PROJECT: 3090 Zone North Interim Tank

TECHNICAL DRAINAGE STUDY SUPPLEMENT
(Response to CLV Comments)

3090 Zone North Interim Tank

Subject: Supplement to the Response to CLV Comments to the Technical Drainage Study for 3090 Zone North Interim Tank (DS-4854)

EX-1

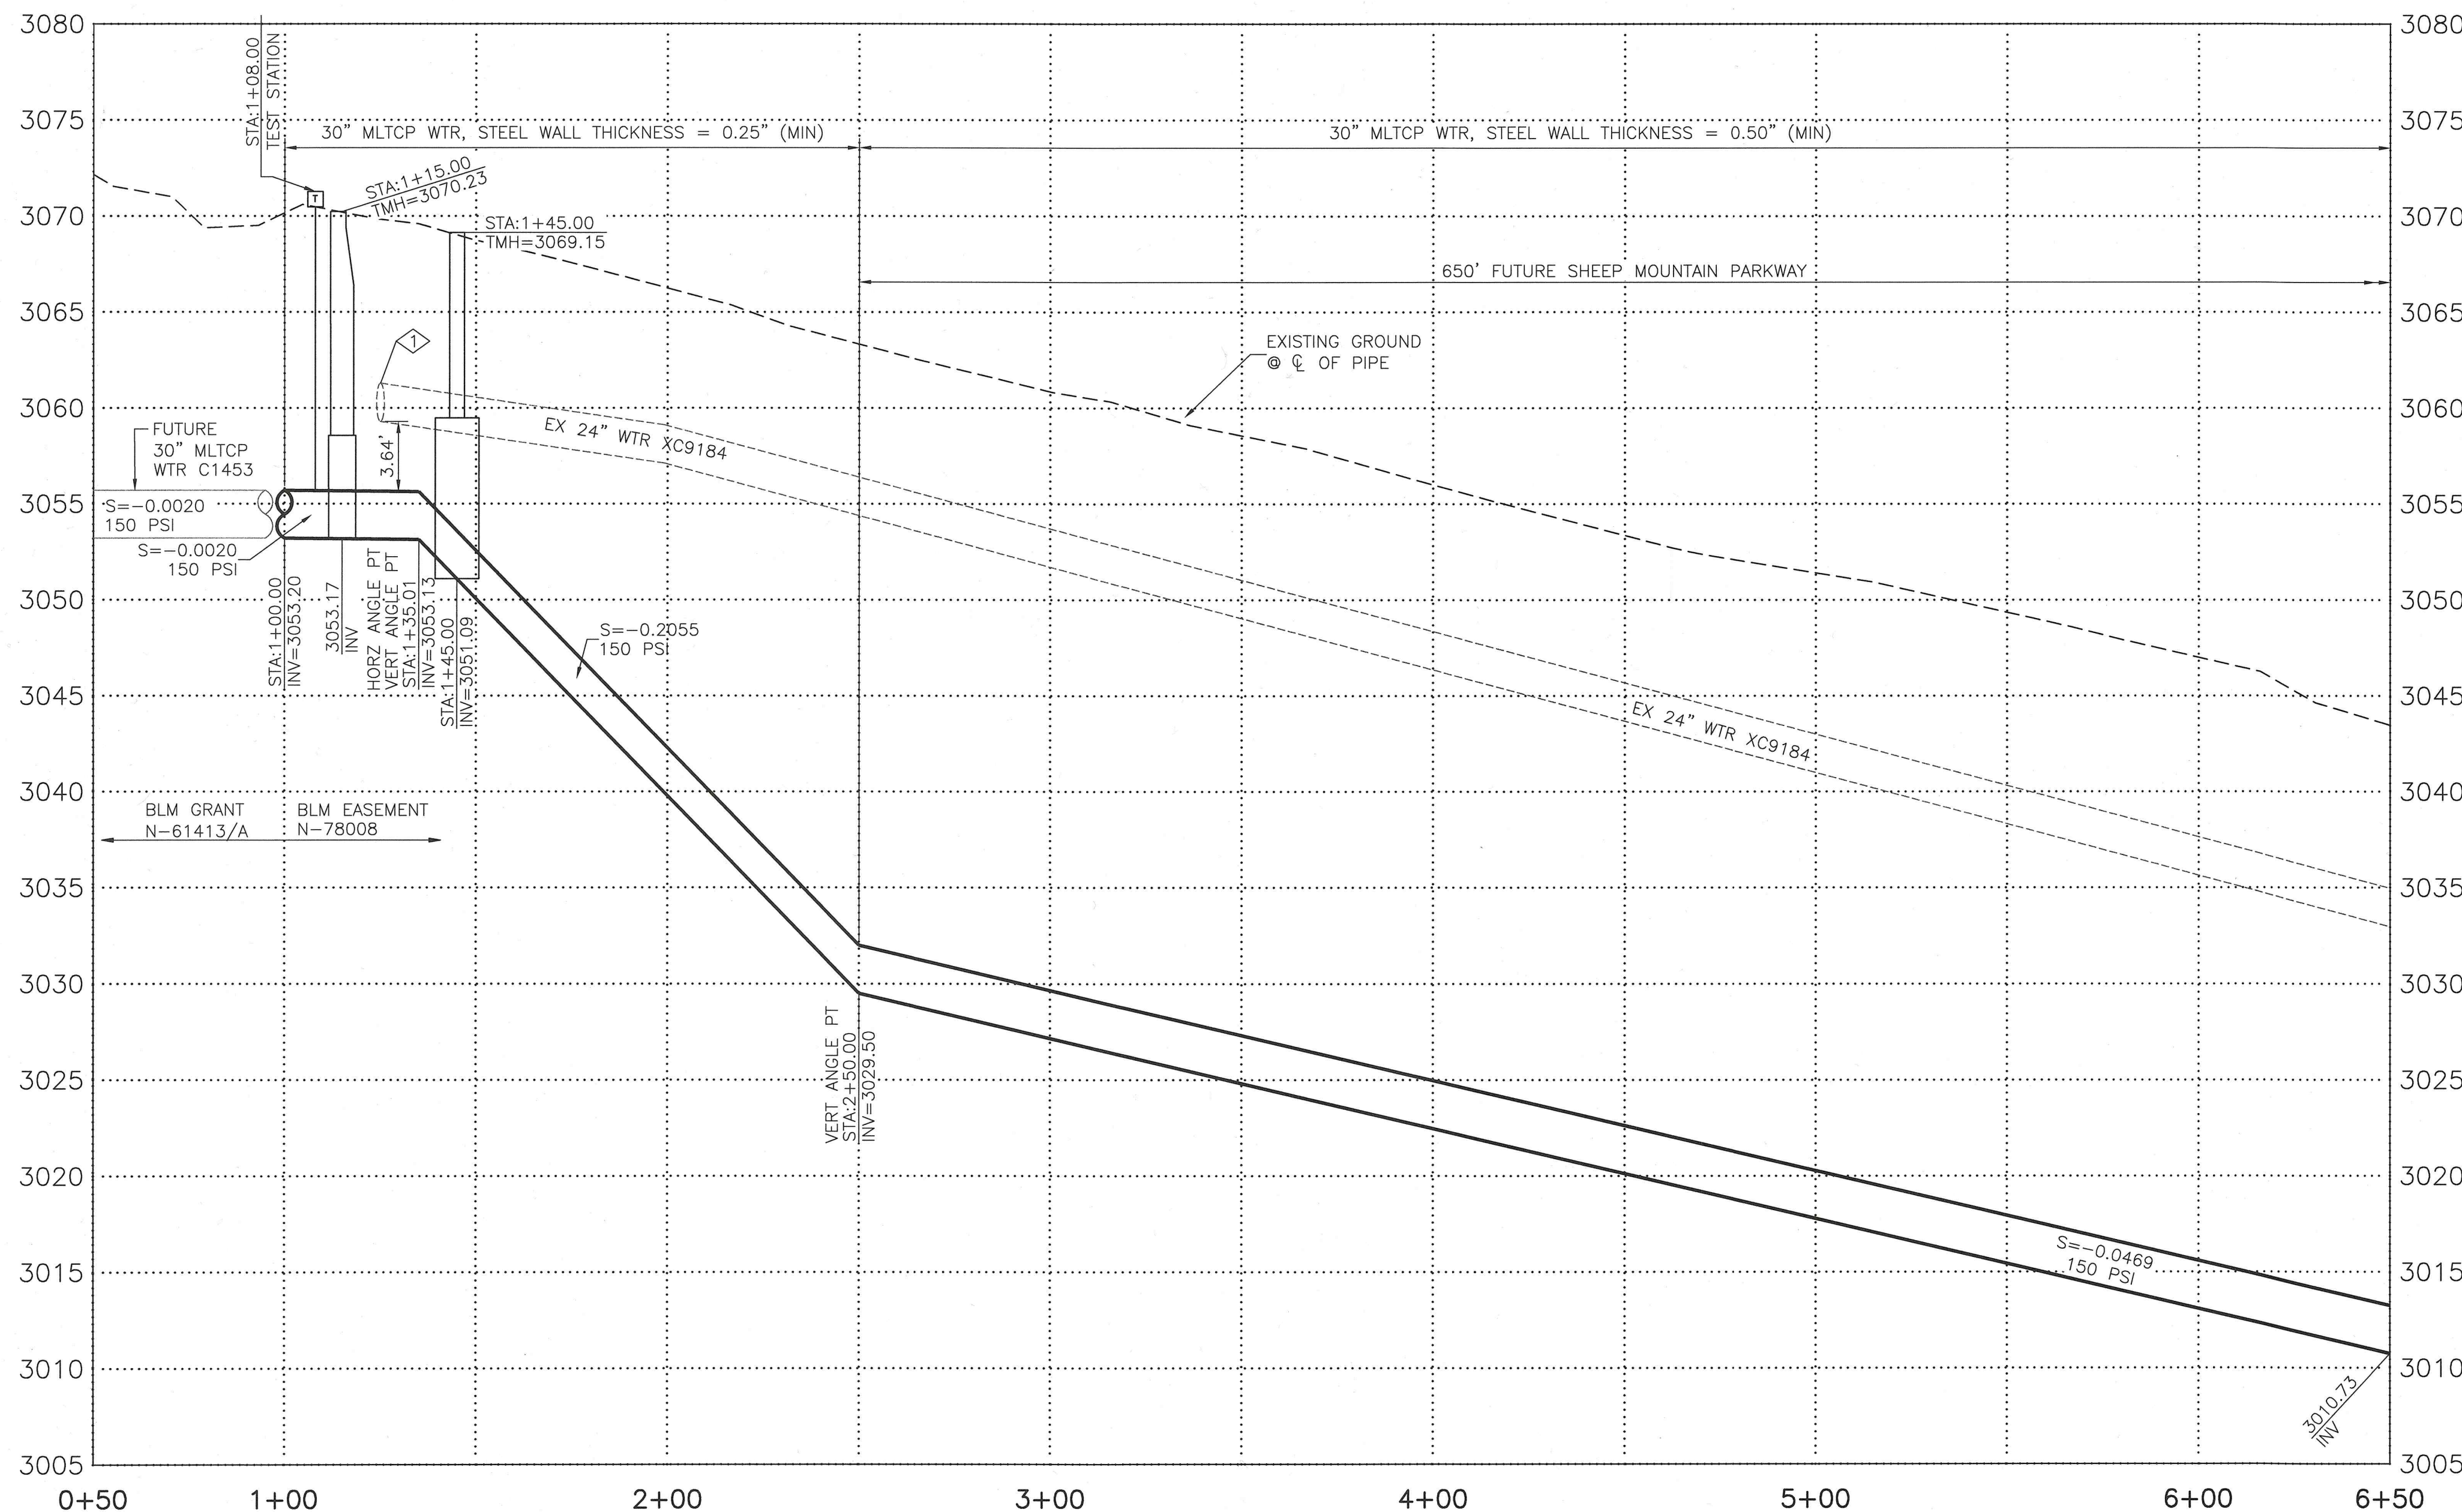
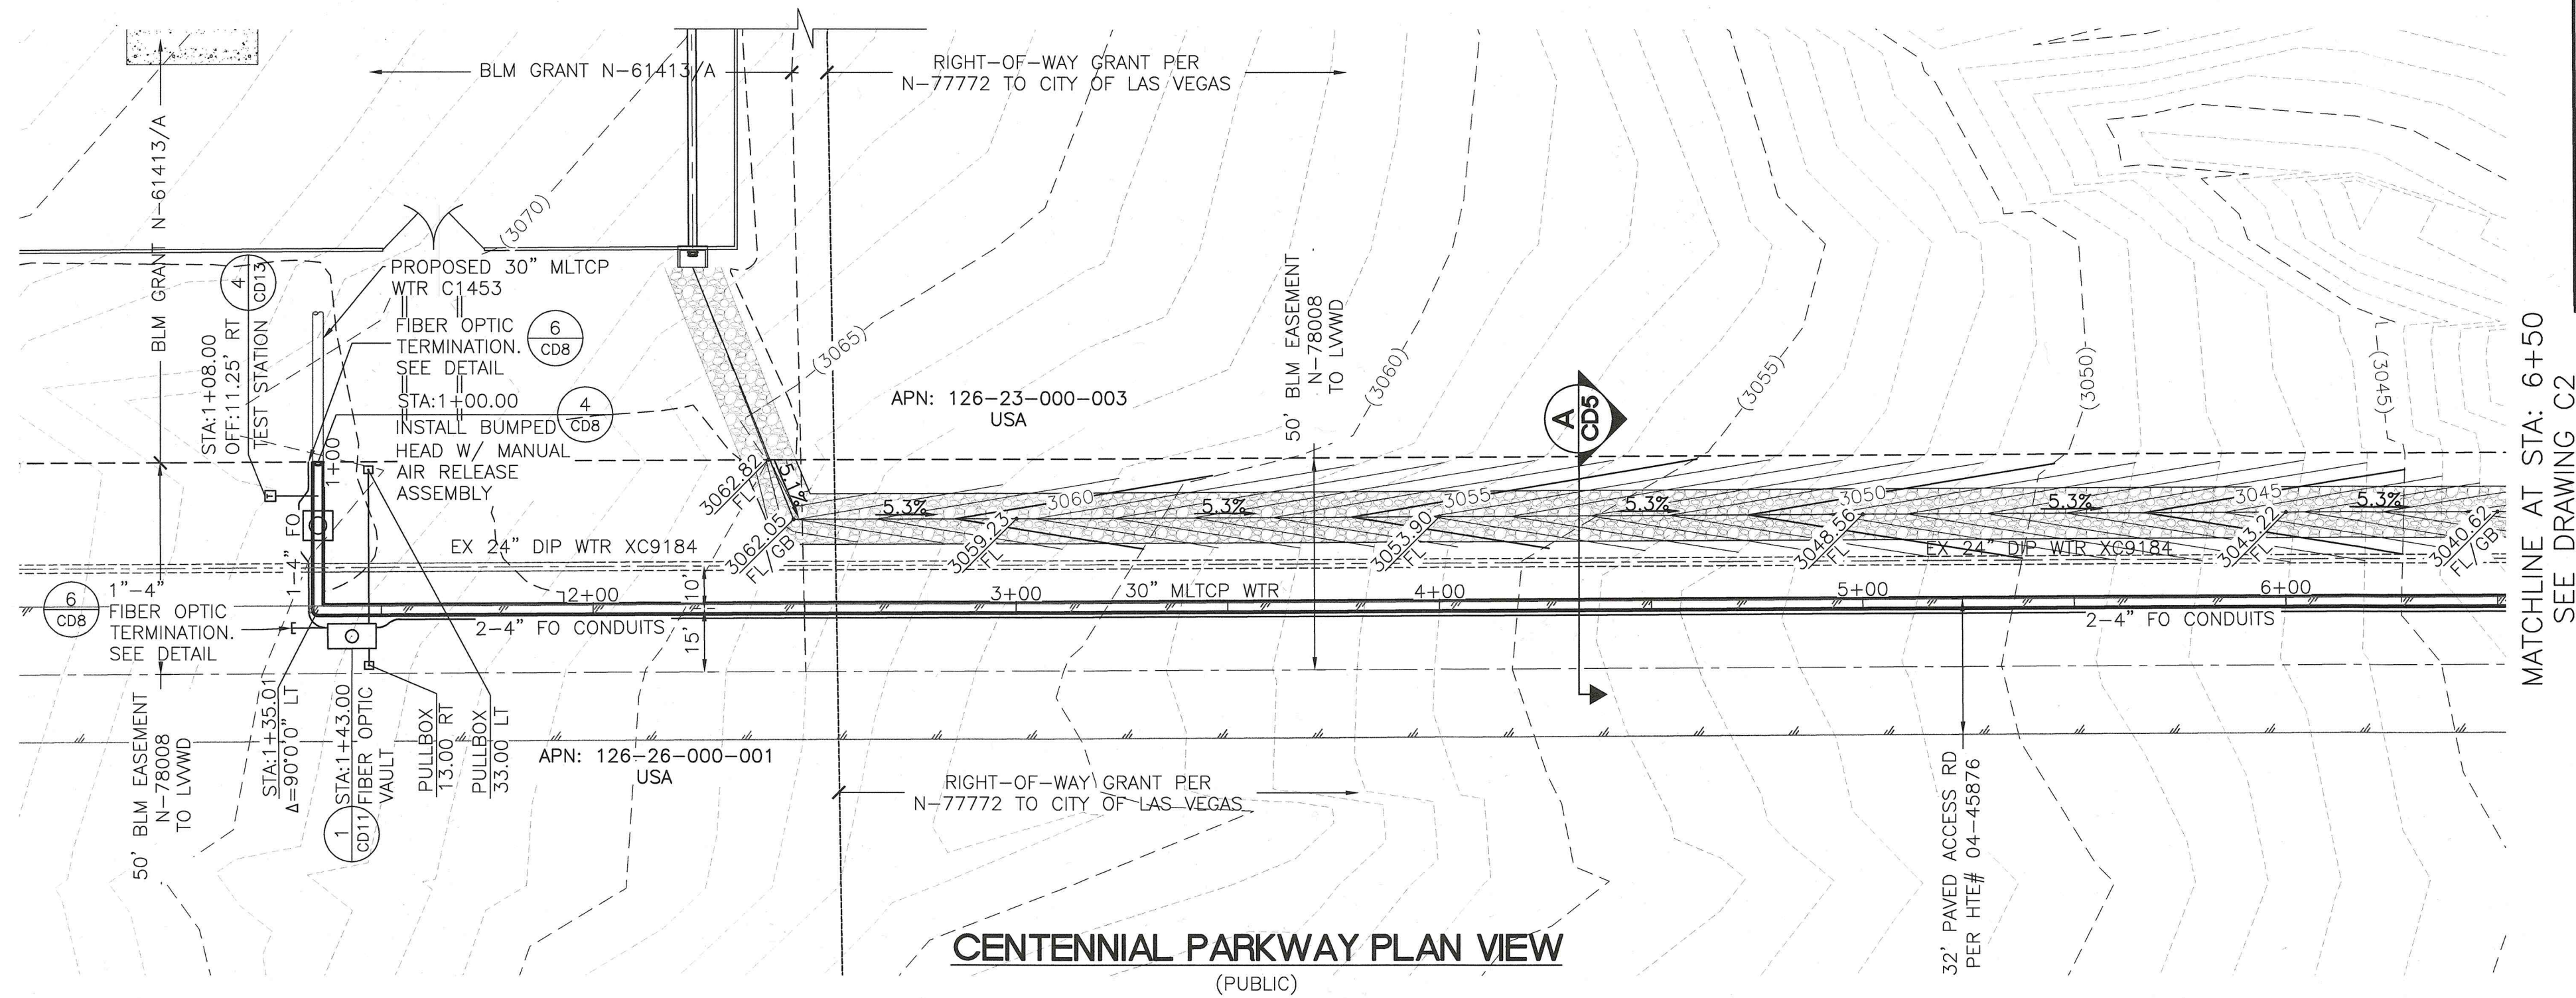
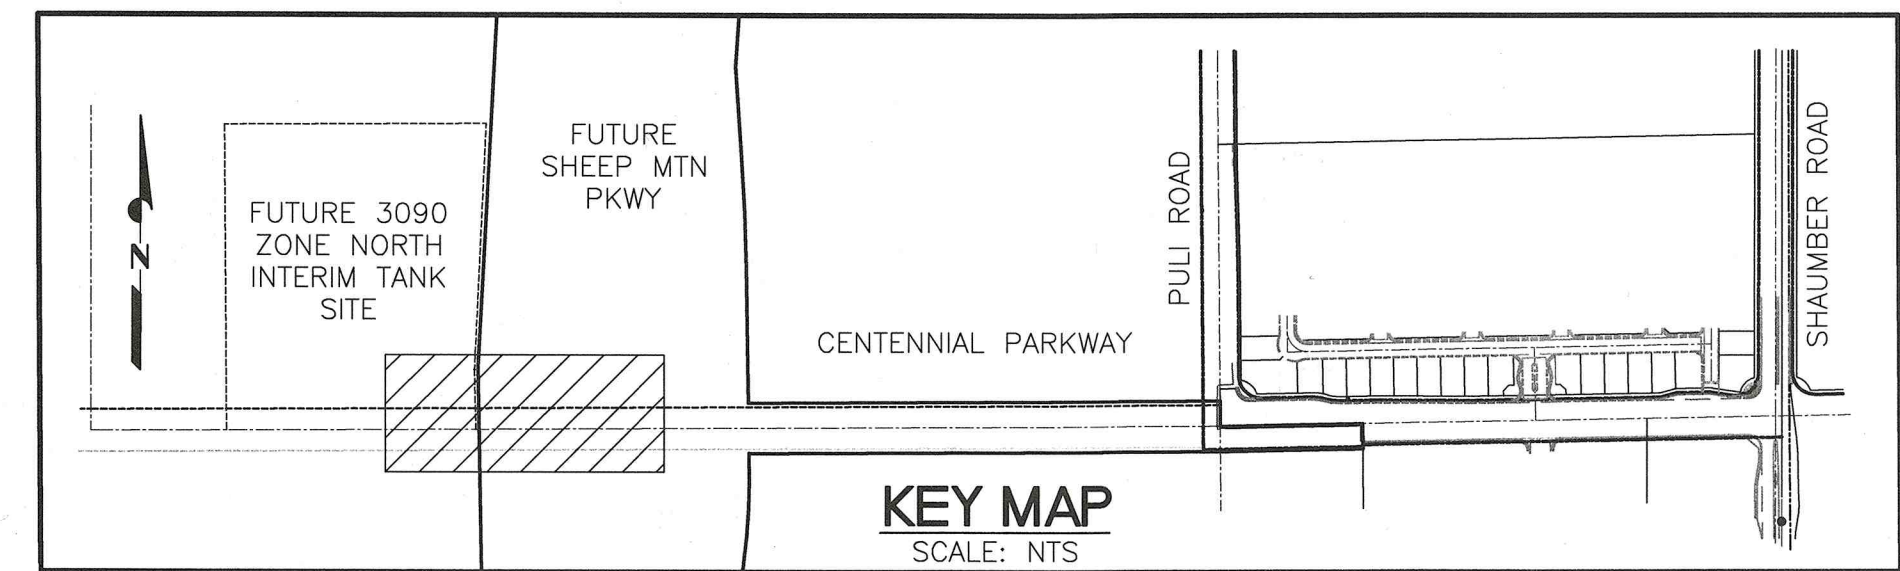
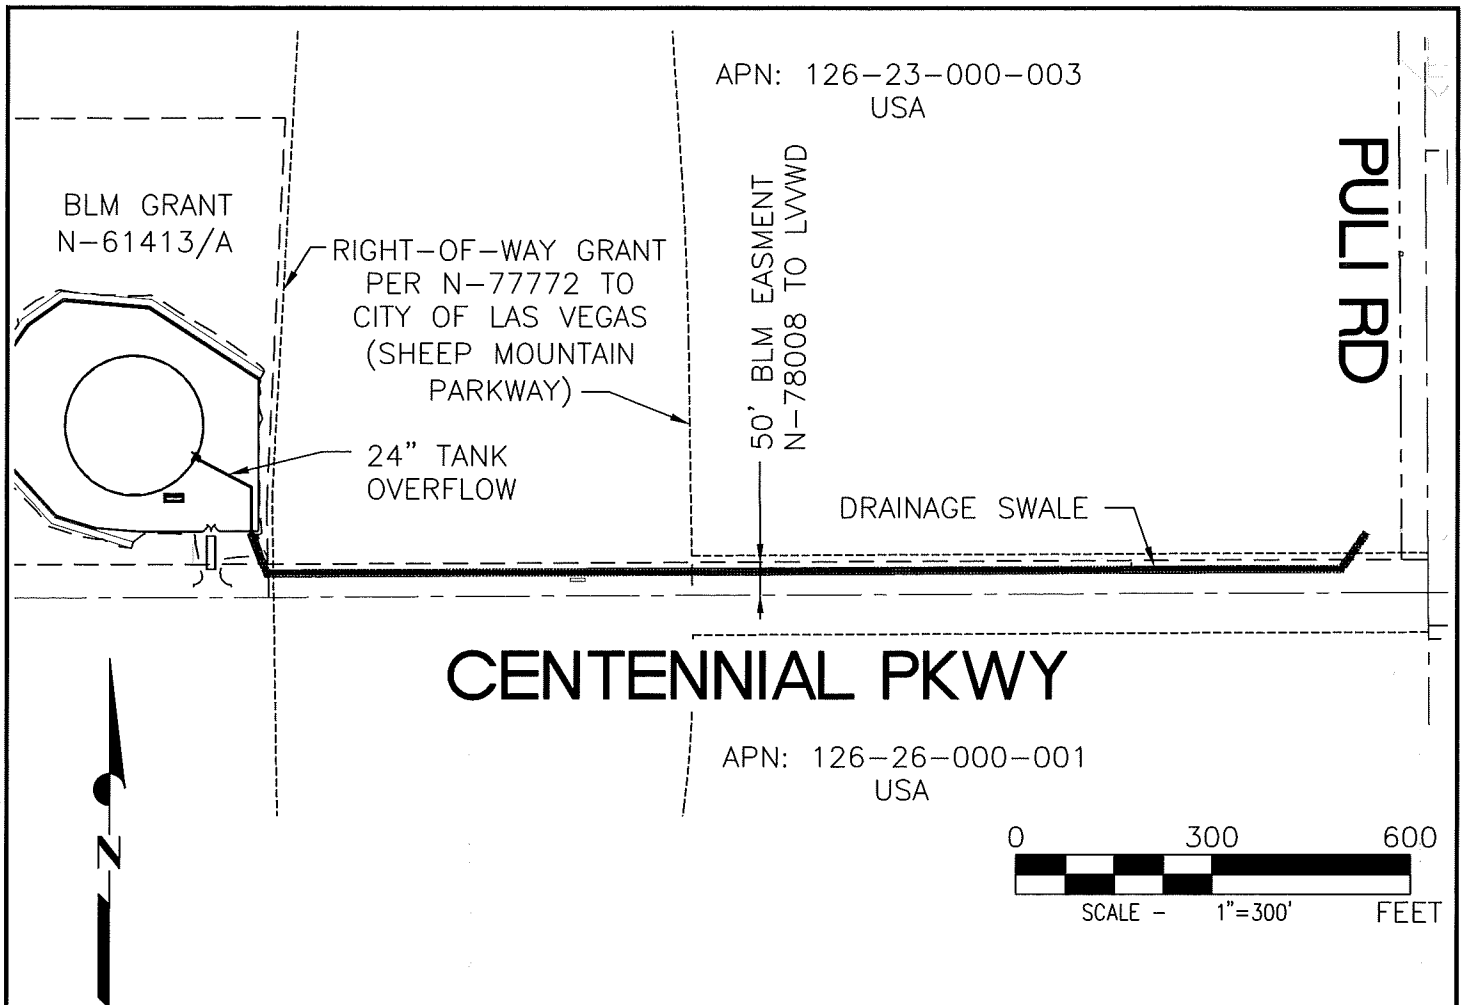
1. **Condition:** *The project proposes to build a temporary drainage swale in Centennial Parkway between the proposed water tank and Puli Road alignment. Prior to final plan approval the developer must complete a maintenance and liability agreement for the interim drainage improvements (off-site berms or channels) and post a minimum maintenance bond of \$25,000 or 25-percent of the construction cost for the improvements, whichever is greater. The engineer must submit an estimate of the quantities for constructing the facility and an 8.5-inch by 11-inch exhibit that adequately shows the location and limits of the drainage facility to Flood Control for approval. Once the drainage study is conditionally approved, the engineer should contact the City's Land Development Section (229- 6371) to begin the agreement process.*

- The project proposes to build a temporary drainage swale in *Centennial Parkway* between the proposed water tank and *Puli Road* alignment. Prior to final plan approval the developer must complete a maintenance and liability agreement for the interim drainage improvements (off-site berms or channels) and post a minimum maintenance bond of \$25,000 or 25-percent of the construction cost for the improvements, whichever is greater. The engineer must submit an estimate of the quantities for constructing the facility and an 8.5-inch by 11-inch exhibit that adequately shows the location and limits of the drainage facility to *Flood Control* for approval. Once the drainage study is conditionally approved, the engineer should contact the City's Land Development Section (229-6371) to begin the agreement process.

Response: Acknowledged. Prior to the final plan approval, the maintenance and liability agreement for the interim drainage improvements will be submitted to CLV Flood Control for review. The maintenance and liability agreement will be coordinated once the drainage study is conditionally approved. The exhibit illustrating the location and limits of the drainage facility identified as Exhibit EX-1 has been provided in Appendix C.

DRAINAGE SWALE QUANTITIES	
EXCAVATION	2,640 CY
GEOTEXTILE	2,293 SY
RIPRAP D ⁵⁰ =12"	1,129 CY
RIPRAP D ⁵⁰ =18"	600 CY
